# SERVICE BULLETIN

## NO. A3312-71-1

POWER PLANT-FAN COWL-HOLD OPEN ROD  
REPLACE OUTER TUBE RIVETS

FIGURE 1 — OUTER TUBE AND END CAP

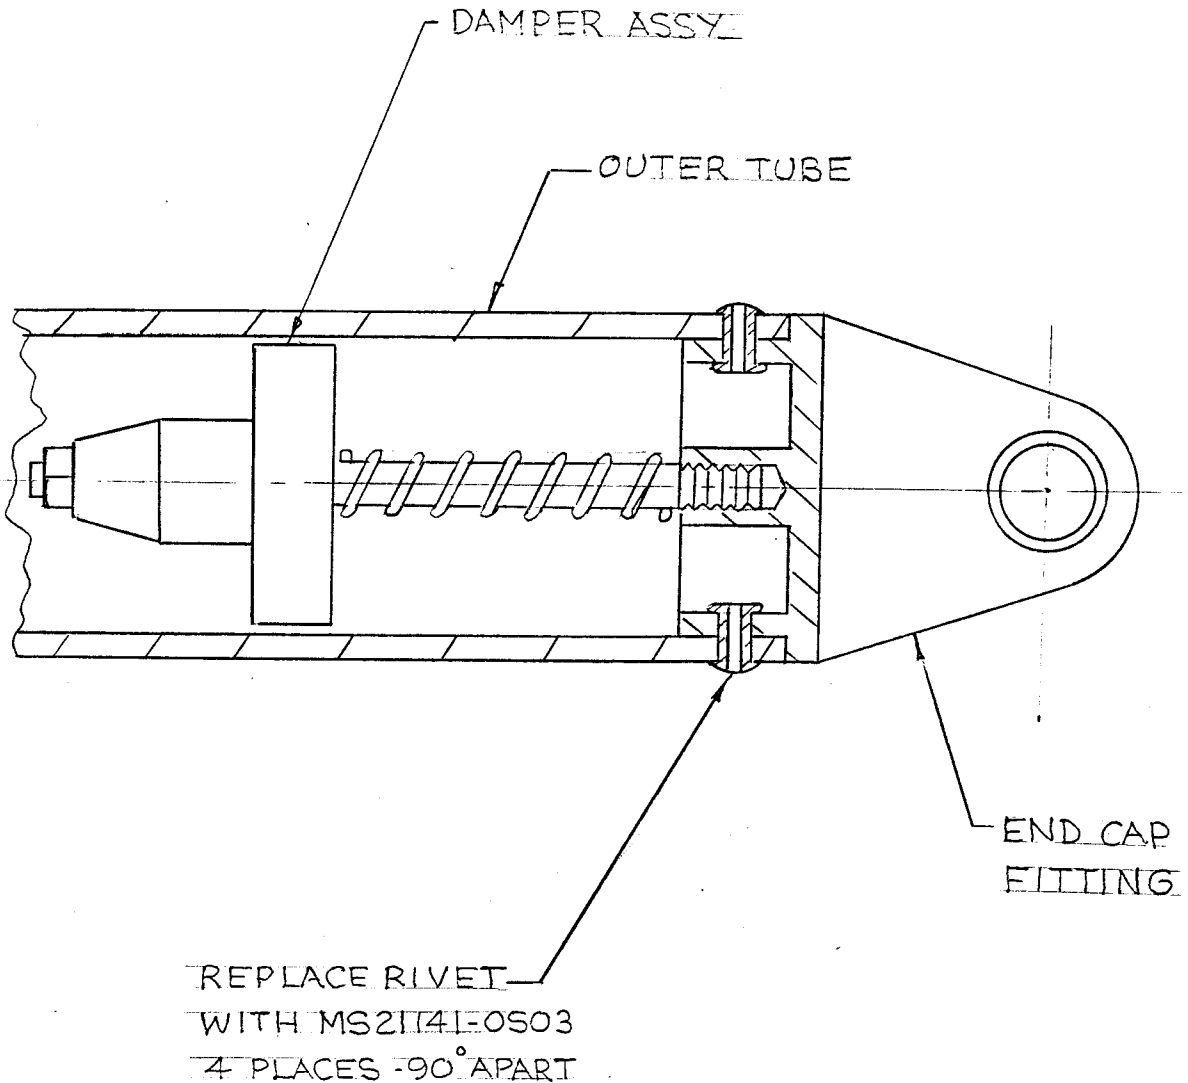
- A. Drill out four (4) rivets in outer tube, shown in Figure 1, using a No. 19 drill (.166 inch diameter).
- B. Place a mark on the outer tube and end cap to indicate alignment of the four holes. Remove end cap assembly from the outer tube.

- E. Install four (4) MS21141-0503 rivets using a double action tool as indicated on sheet 1 of the attached Military Standard MS21141.
- F. Clean area immediately following NORCO P/N A3312-1 by rubbing with wiper damped with Aliphatic Naphtha, TT-N-95, or equivalent, until soil is removed. Do not allow solvent to evaporate. Avoid removing pretreatment or finish coating. After soil is removed, wipe the area dry with a clean dry wiper. Using rubber stamp letter size 1/8" to 3/16" and Alcosol or F-100 stamp pad ink, or equivalent, apply the letter "M" immediately following the dash number "-1". Clean stamp with naphtha, or equivalent, as required, for mark legibility and sharpness. Allow ink to dry at least ten minutes and overcoat with Bostik 683-3-2 or 683-3-9 or equivalent.
